GEOCRES No. 30M13-60

LOCATION C.N.R. Overhead

Ramp 400S-407 E-W

GEOTECHNICAL INVESTIGATION

CNR OVERPASS
RAMP 400 S TO 407 EW
(400 DETOUR)
TRACK PROTECTION

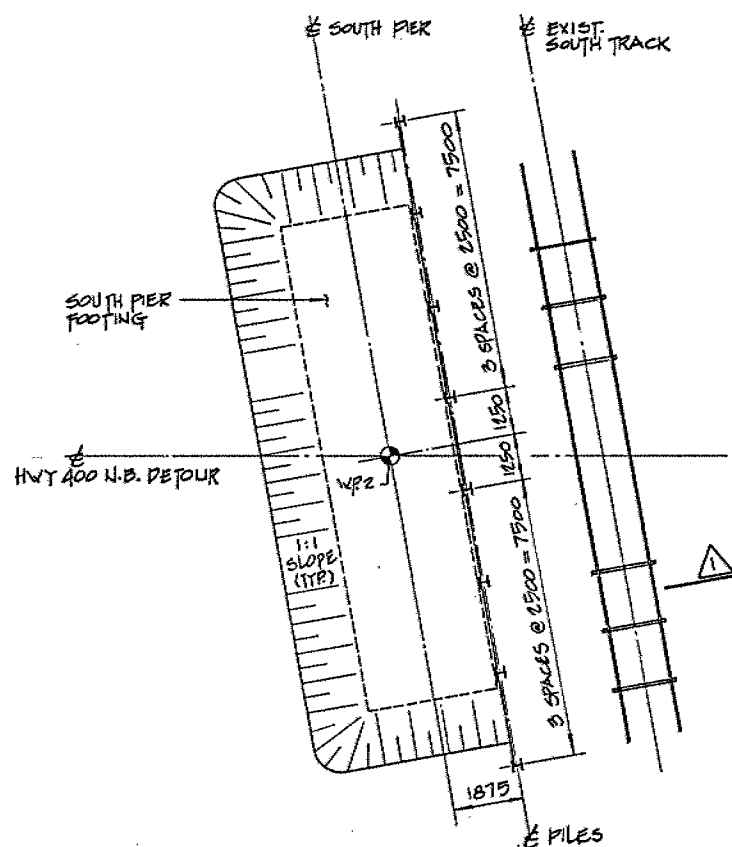
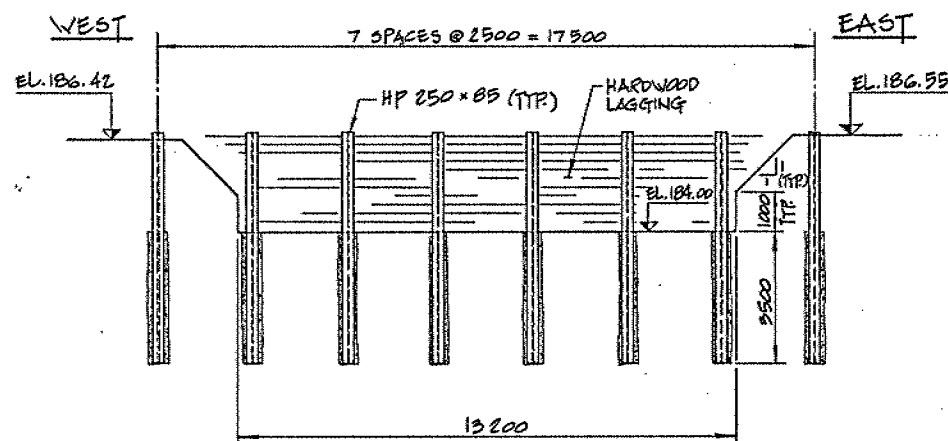
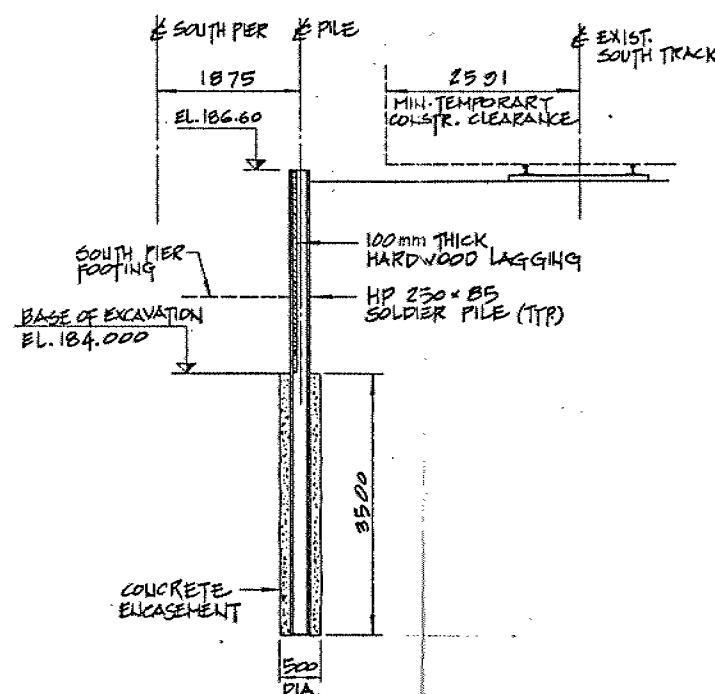
The submitted final drawings and provisions have been reviewed by this section.

As discussed in a meeting on December 8, 1987, a soldier pile/lagging cantilever system with a 500 mm diameter lean concrete encasement should be implemented below the base of excavation for the south abutment. All soldier piles in the vicinity of the foundation should be left in place cut off 1 m below the final grade, and covered with fill material to prevent long term softening of the subsoils as a result of pile extraction and water ingress into the resultant pile cavities.

LIMIT FOR EXCAVATION FOR FOUNDATIONS
BETWEEN CNR O'PASS & 400 N.B. DETOUR
OVER RAMP TO STEELES AVE E.W.

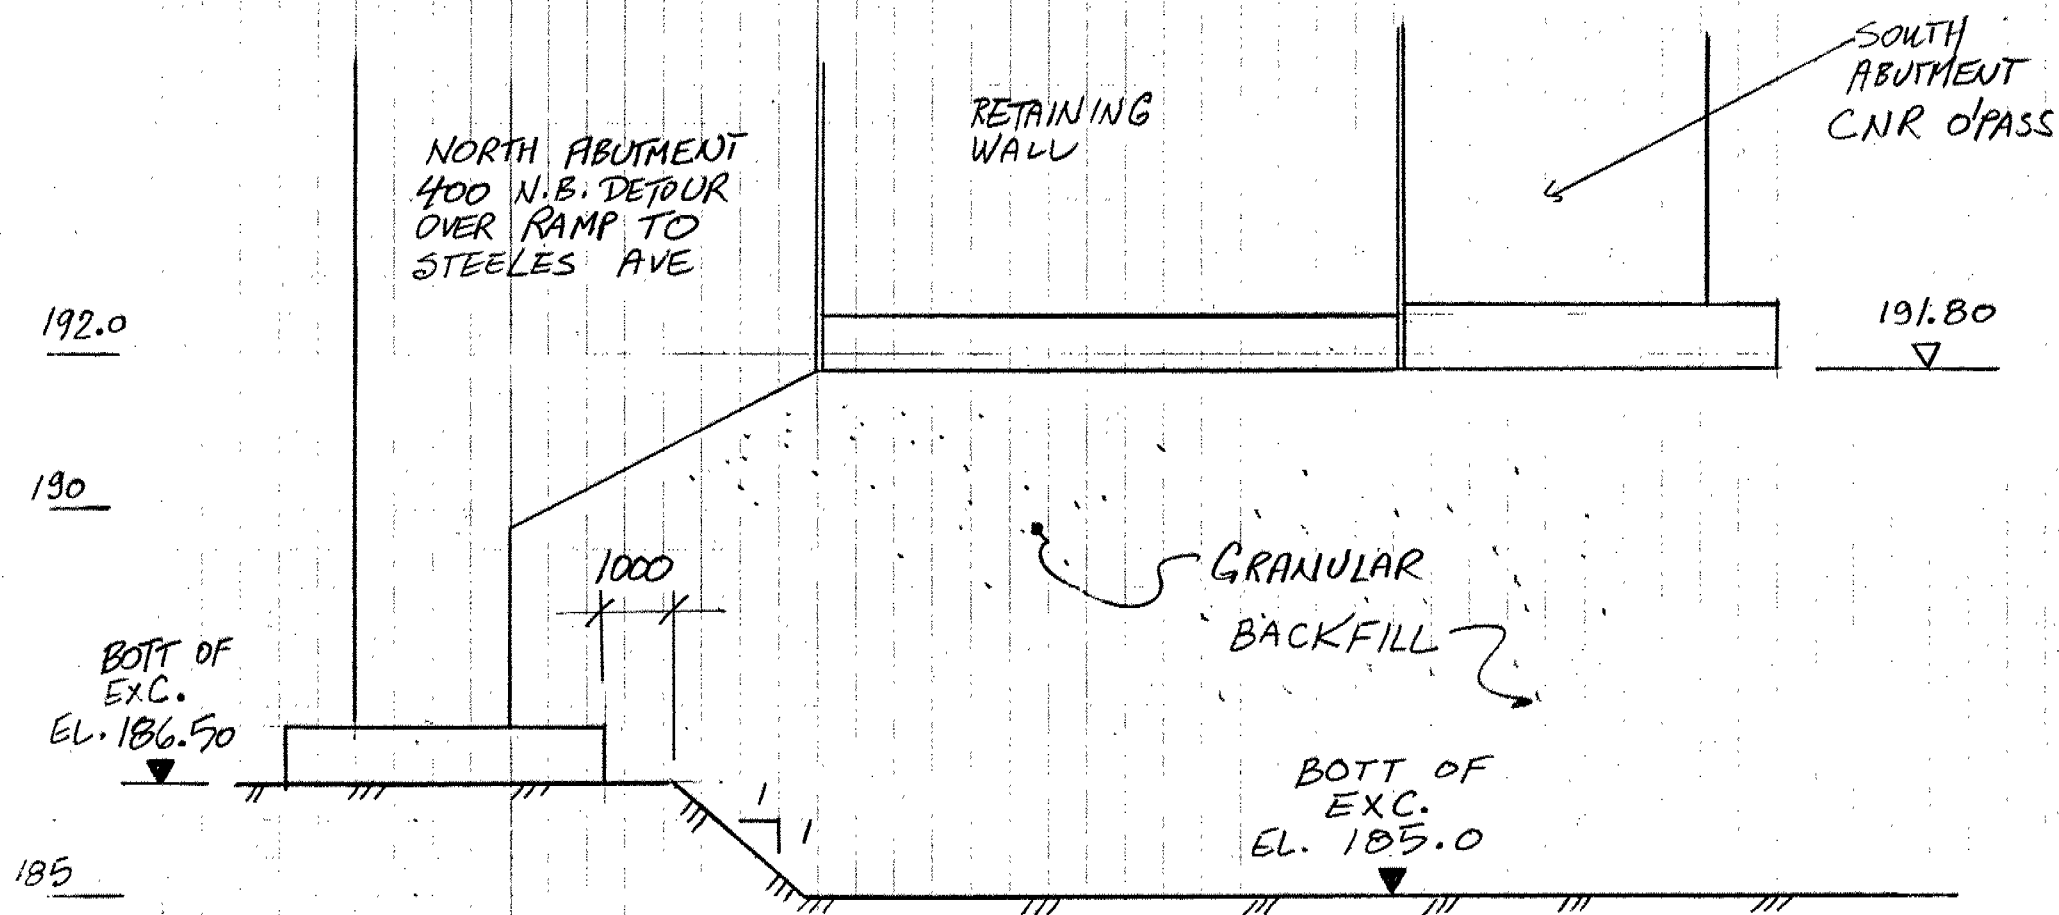
To review and finalize bottom of excavation in area between CNR O'Pass and Hwy 400 N.B. Detour over the ramp to Steeles Ave.

The soil data around this area was reviewed and it was decided that the bottom of excavation shall be stepped from 186.50 for the north abutment of the structure of the Hwy 400 N.B. Detour over the ramp to Steeles Ave E.W. to 185.00 for the CNR O'Pass. Dennis Wong was given the guidelines to work out the boundary. A proposed detail by Dennis Wong is attached with this minute.

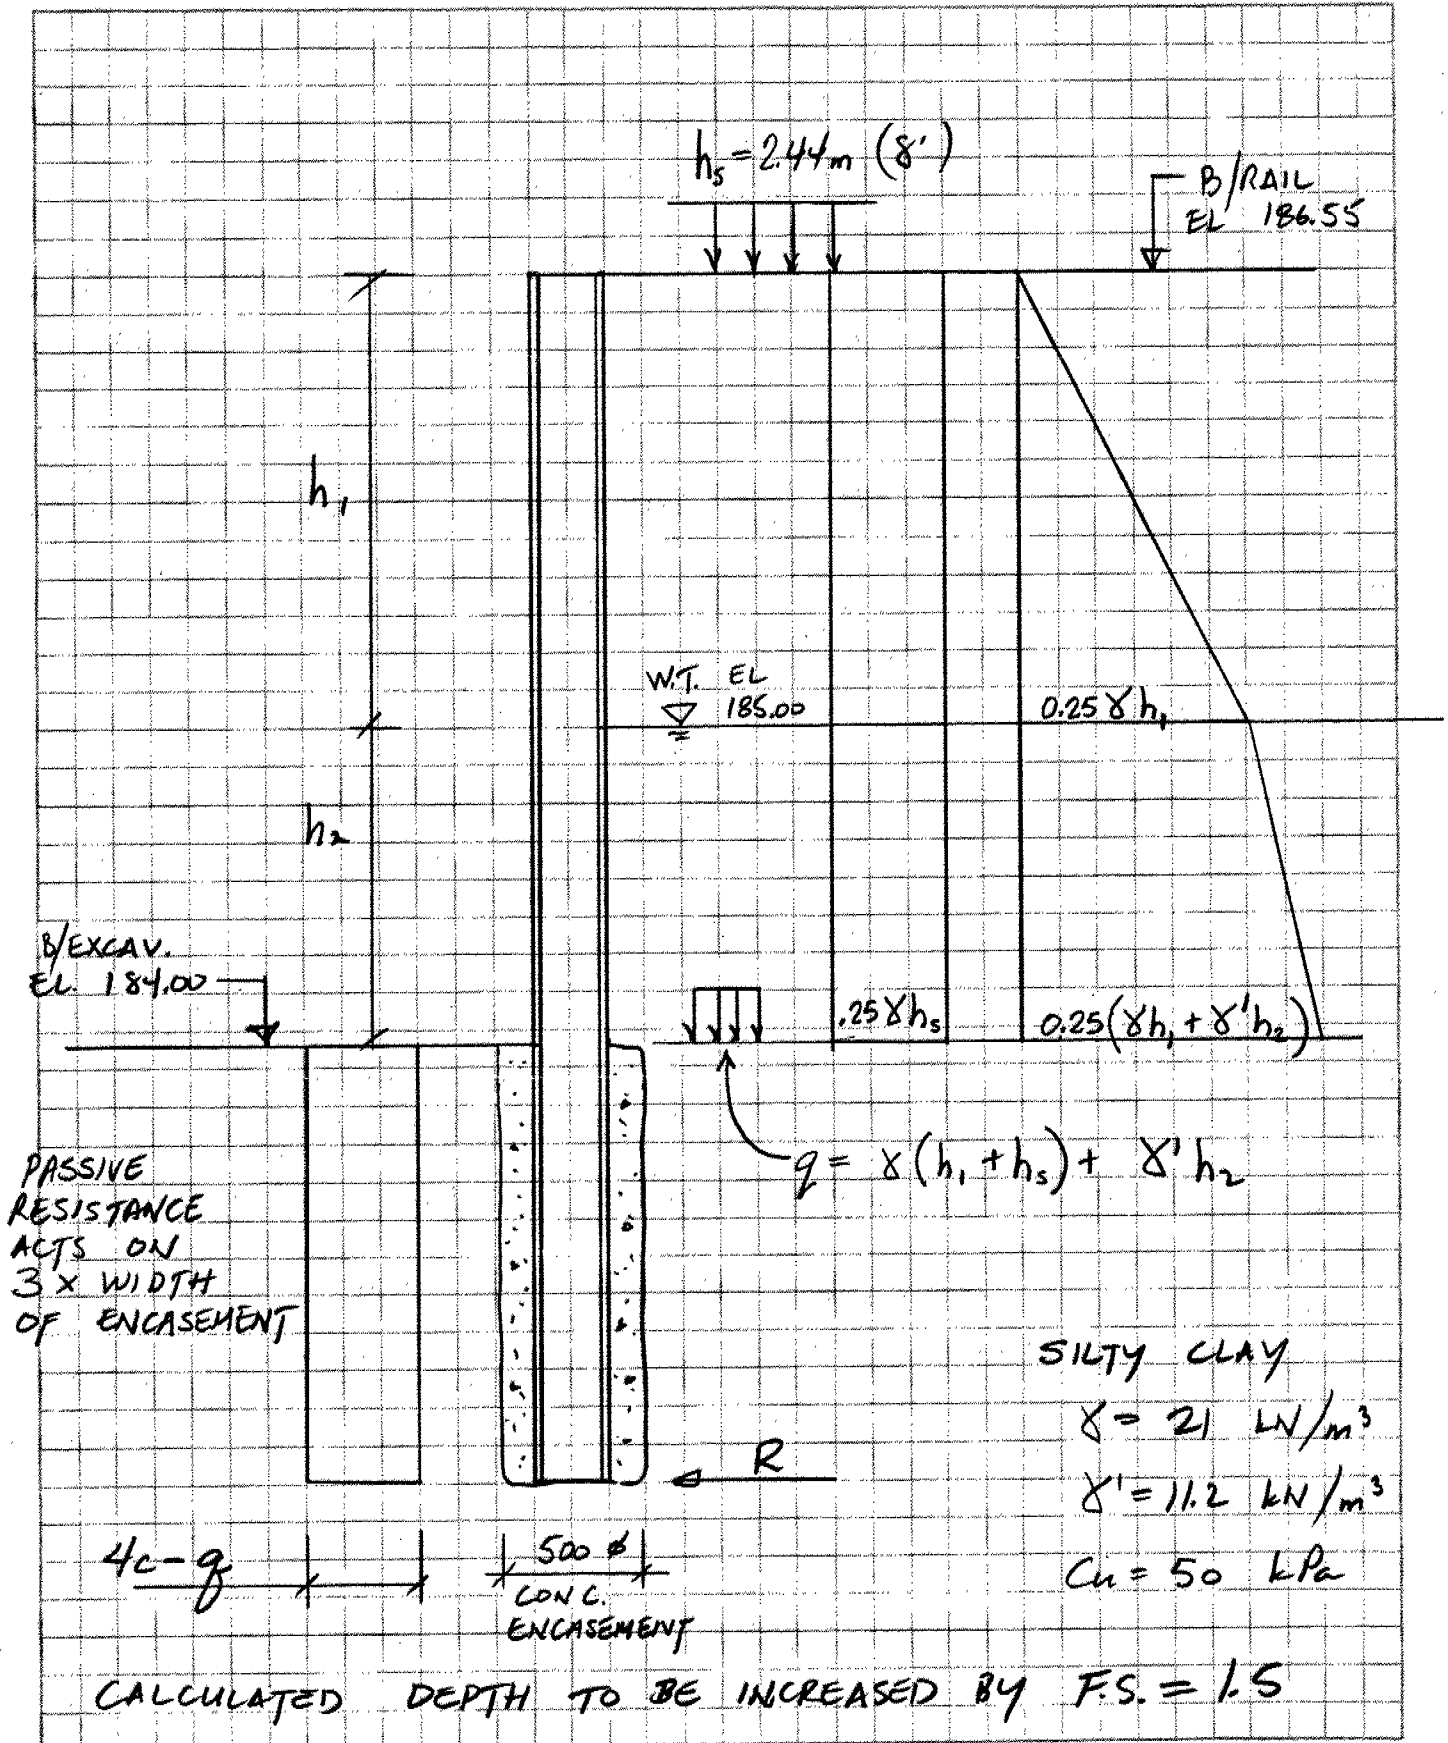
1. The track protection for the south pier of the CNR Overpass, Ramp 400 S to 407 EW was discussed.
2. Mr. Devata recommended a soldier pile/lagging cantilever system with a 500 mm diameter lean concrete encasement below the base of excavation. Preliminary design calculations indicated that a 2.0 m pile embedment below the base of excavation (El. 184.00) would be adequate with a 6'-8' pile spacing. This however did not include the railway surcharge loading.

3. R. Stofko pointed out that the equivalent railway surcharge loading is 8' of fill.
4. The design criteria was discussed and agreed upon. See attached figure.

5. During augering and installation of piles, the minimum railway construction clearance would be infringed upon. A proposed scheme will be presented to CN Rail for comments.

6. Giffels will investigate the feasibility of reducing the width of the pier footing in order to move the track protection system further away from the tracks.

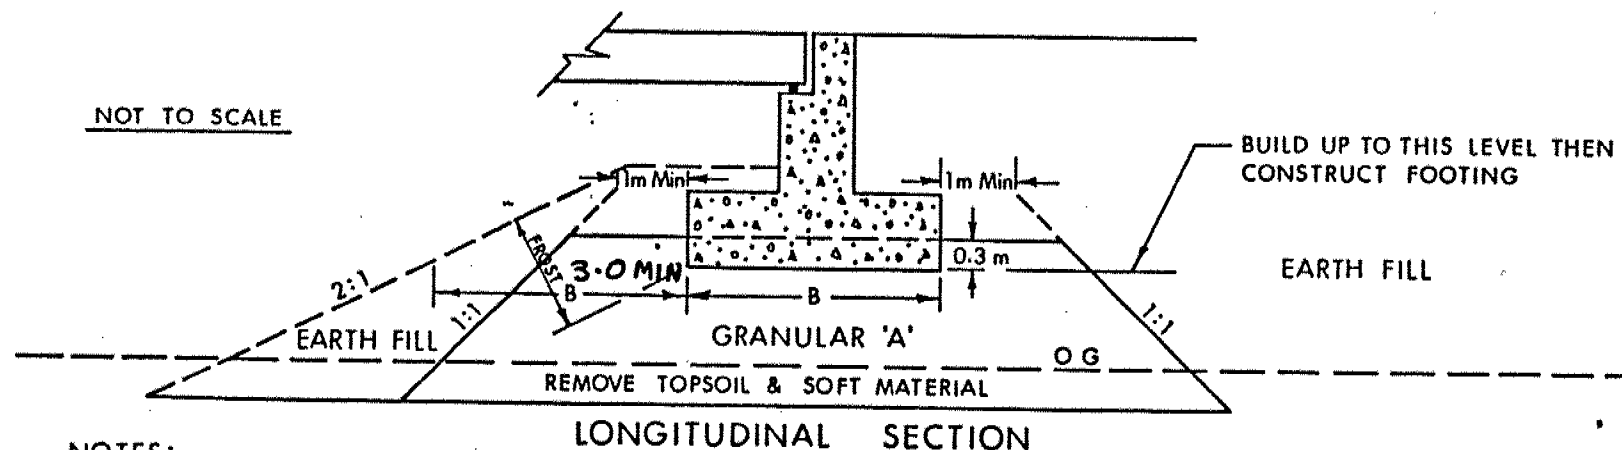
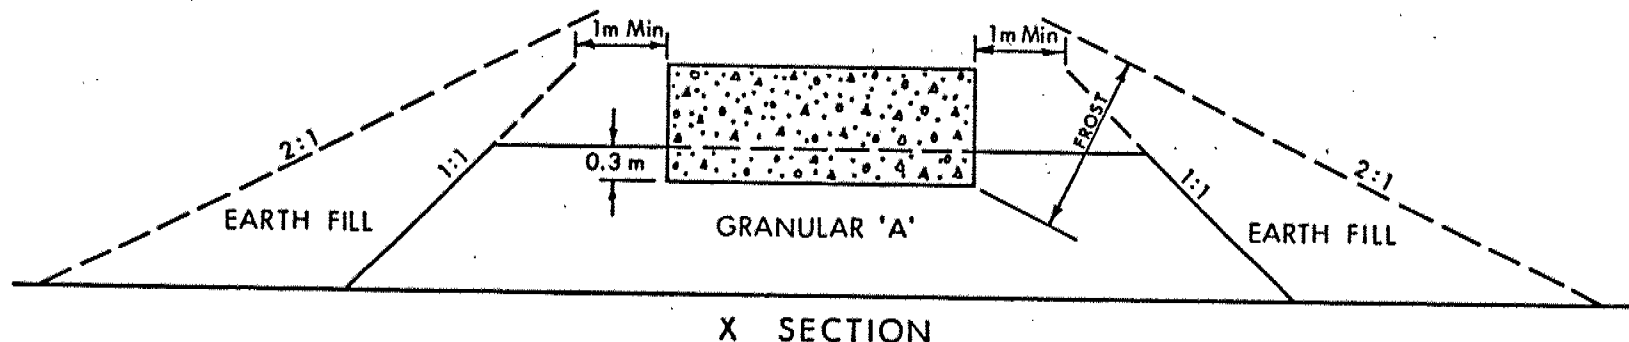
Further to your memorandum dated 87 10 15 and the telephone conversation between your G. Al-Bazi and our T. Kim, we have reviewed the preliminary Drawing No. Pl for the above-noted structure and provide the following comments:

- ✓ 1. To remove the topsoil, fill and the surficially weathered zones of the upper fill, excavation should be reached down to an elevation of 185.0 m for the south abutment and 187.5 m for the north abutment as shown on Drawing No. Pl.
- ✓ 2. The base of the Granular 'A' pad should be placed on the level ground surface as indicated on Drawing No. Pl.
- ✗ 3. It is not clear where the cross-section is taken from the plan (No Arrows).
- ✓ 4. On north abutment, horizontal distance between the front face of the concrete footing and the outer slope should be maintained at least 3000 mm as shown on a sketch of abutment on compact fill attached (existing distance is only 2.4 m).
- ✓ 5. A symbol of a slope at the north abutment should be deleted on the cross section.
- ✓ 6. The original ground surface for both abutments should be revised as shown on Drawing No. Pl.
